CITY OF ALBUQUERQUE

Re: Congress Apartments
9441 Eagle Ranch Rd. NW
Traffic Circulation Layout
Architect's Stamp 09-28-21 (C13-D033)

Dear Mr. McEachern,
Based upon the information provided in your submittal received 10-25-21, the above referenced plan cannot be approved for Building Permit until the following comments are addressed:

9441 Eagle Ranch Rd NW
Traffic Circulation Layout
Architect's Stamp 09-28-21 (C13-D033)

SHEET NUMBER
AS-1.0

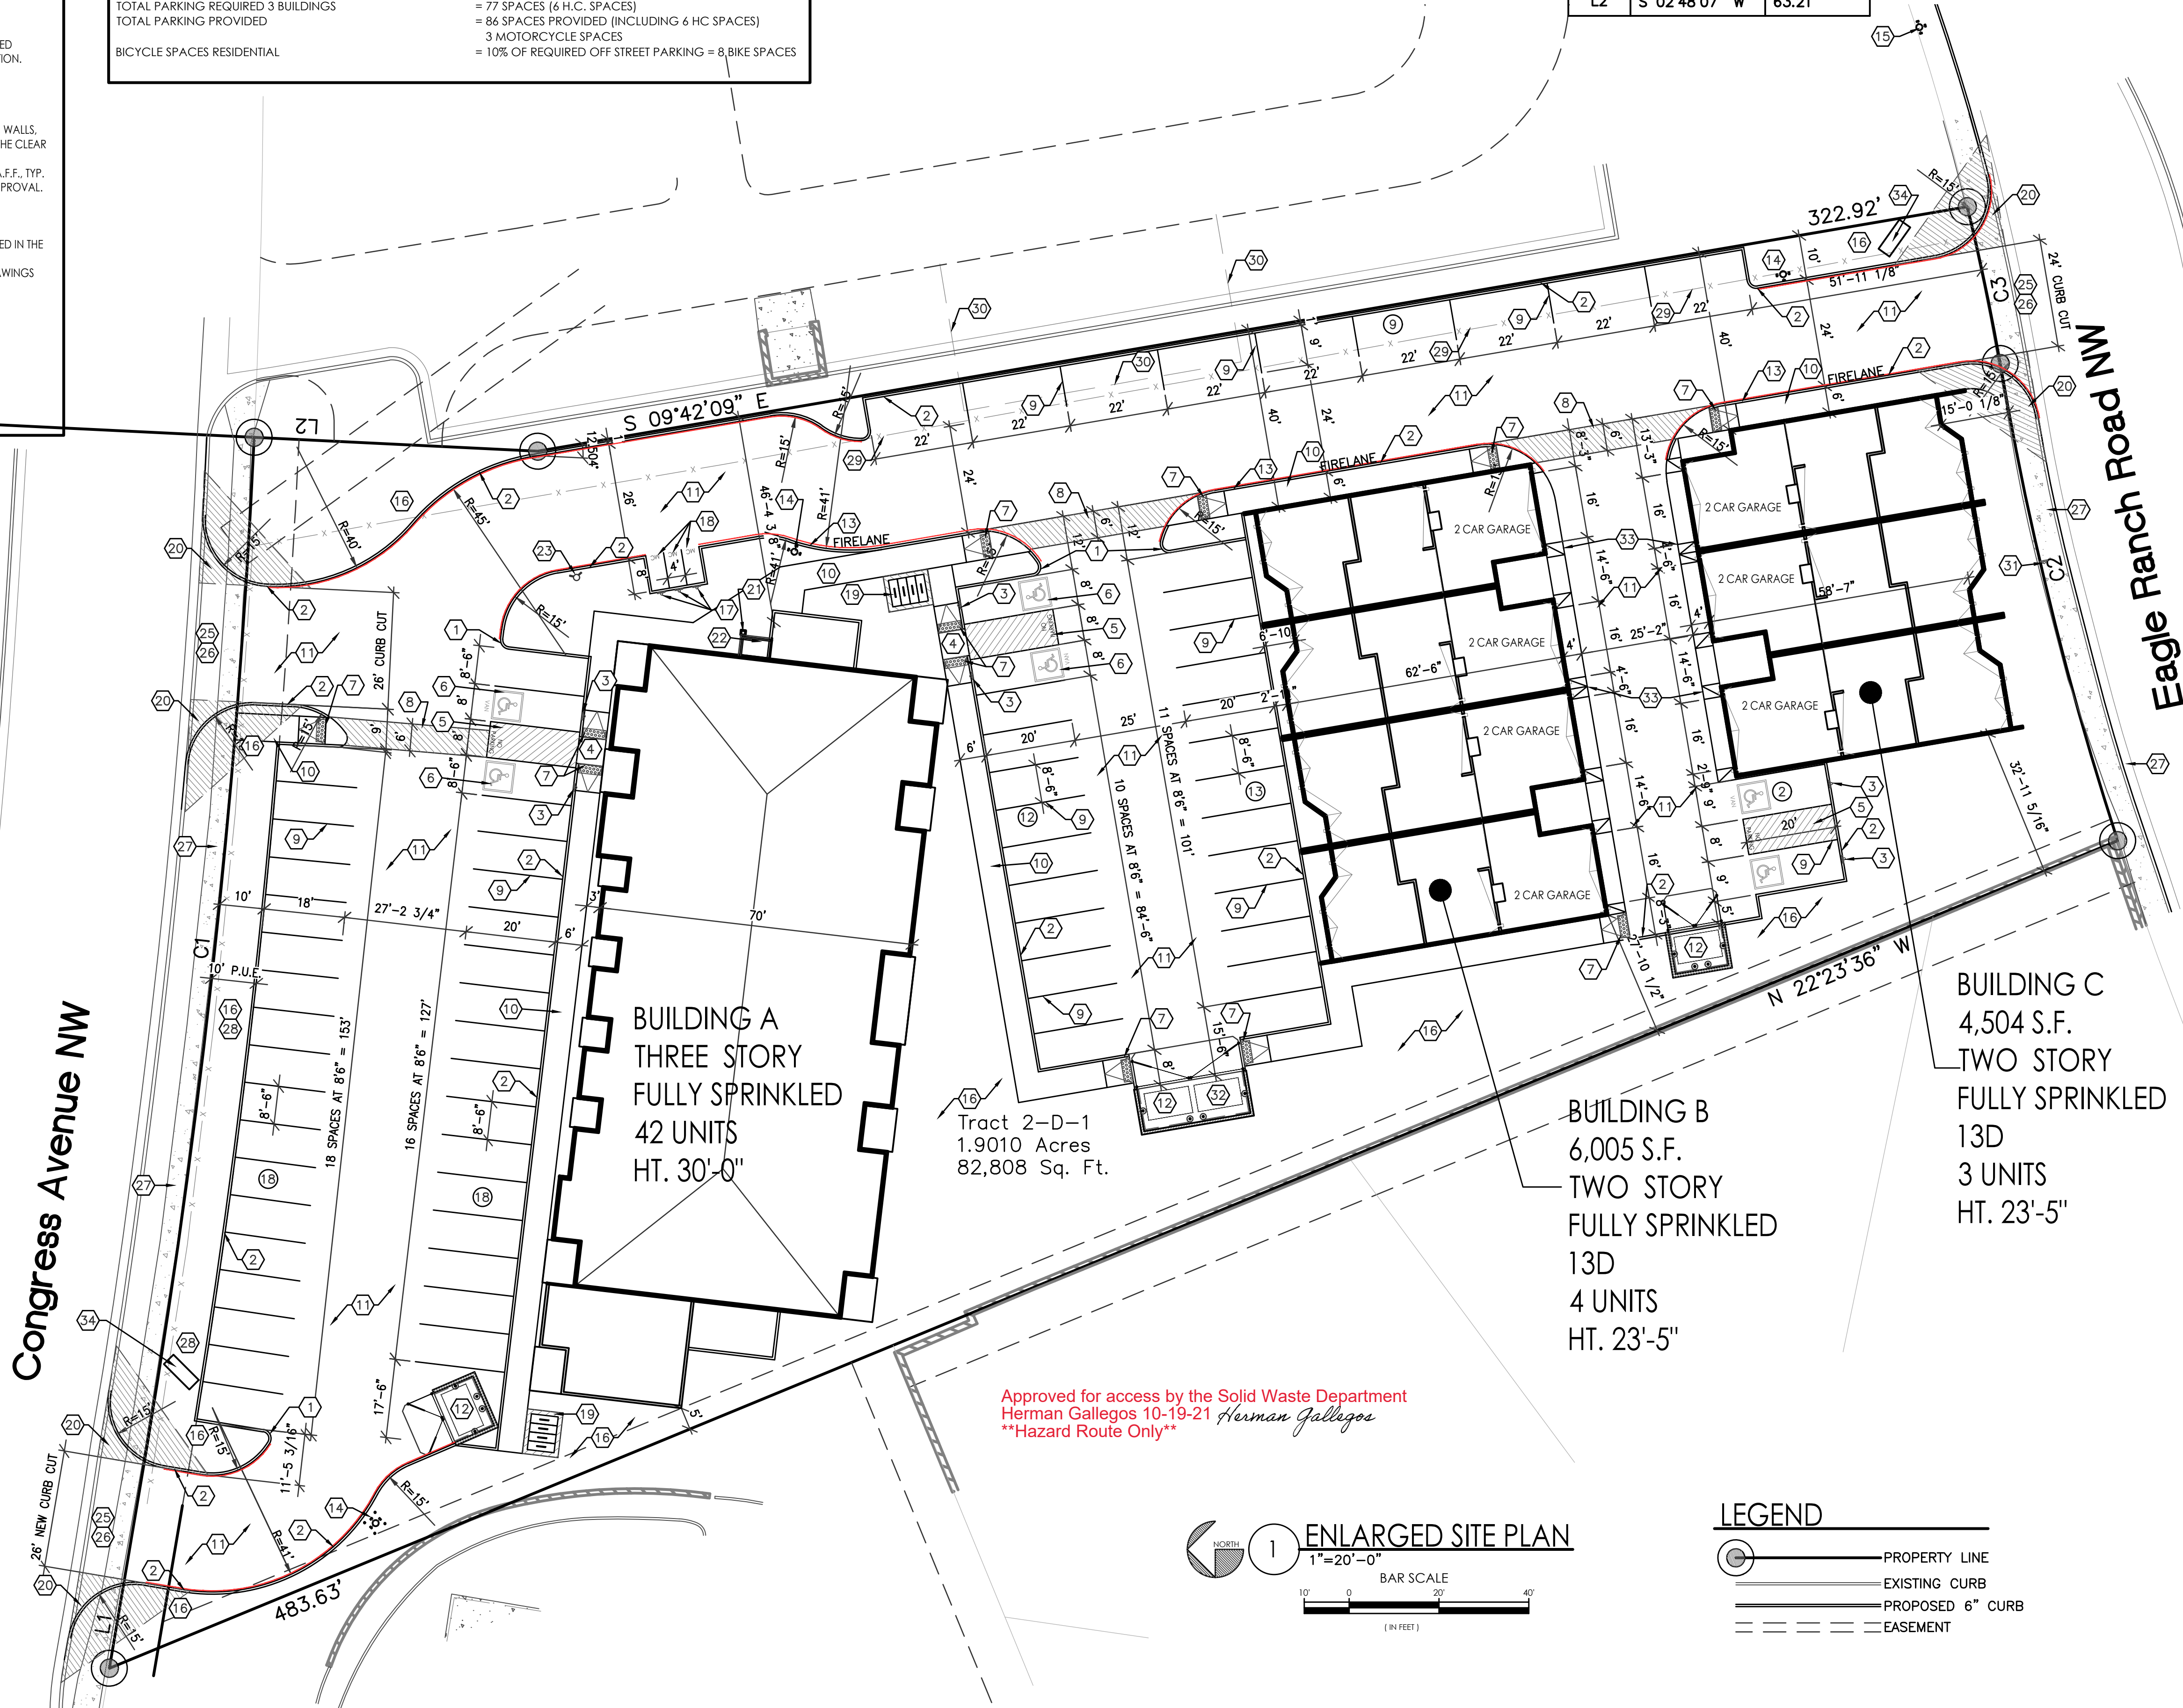
1. Provide a multi-directional ramp at the west leg of the drive entrance off Eagle Ranch Rd. where interior sidewalk connection is to be provided. Call out details.
2. Provide details for the Ramps in front of the Dumpster Enclosure.
3. Key note 20: provide dimensions for the clear sight triangle.
4. ADA aisle between building A and B should be 8.5 ft. wide.
5. The width for the Parallel Parking should minimum 7 ft.
6. Details sheet: Accessible Ramp (A10): The running slope should be 1:12 maximum. Please revise accessible ramp details.

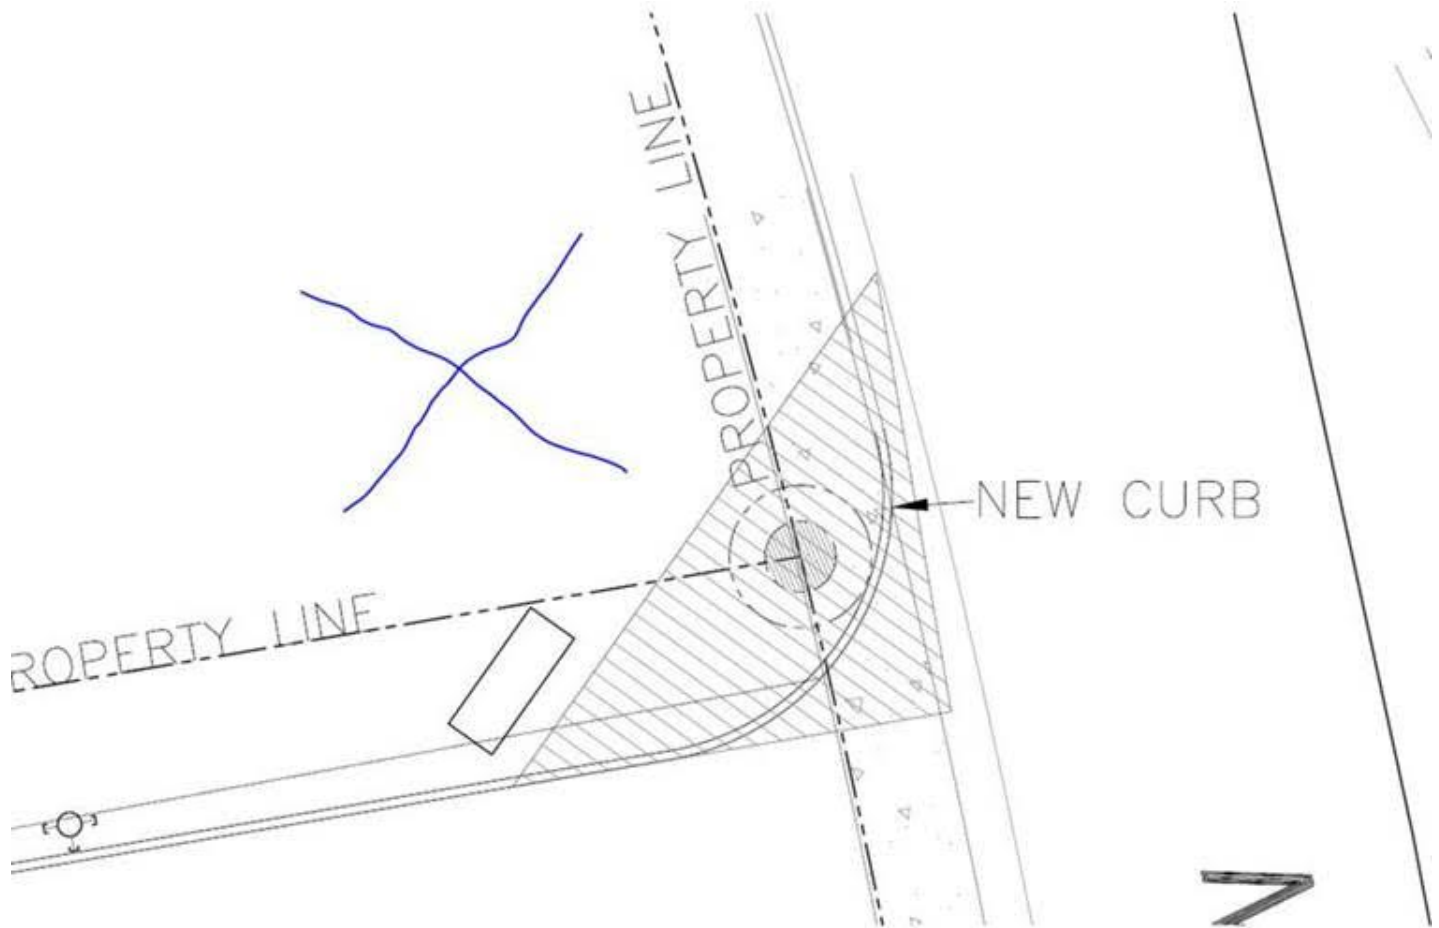
As I mentioned a few weeks ago, we are going to have a "right in / right out" at north end of the property along Eagle Ranch.

The city now requests that we alert the adjacent property owners of the curb cut because it will alter the sidewalk where the driveway begins. This does not encroach on the X-Ray site in any way, but because of the proximity the city would like the adjacent owner to sign off or acknowledge that this will be taking place.

X-Ray Associates is ok with the proposed curb cut. Sam

This looks fine to me as it doesn't encroach or interfere with your property.
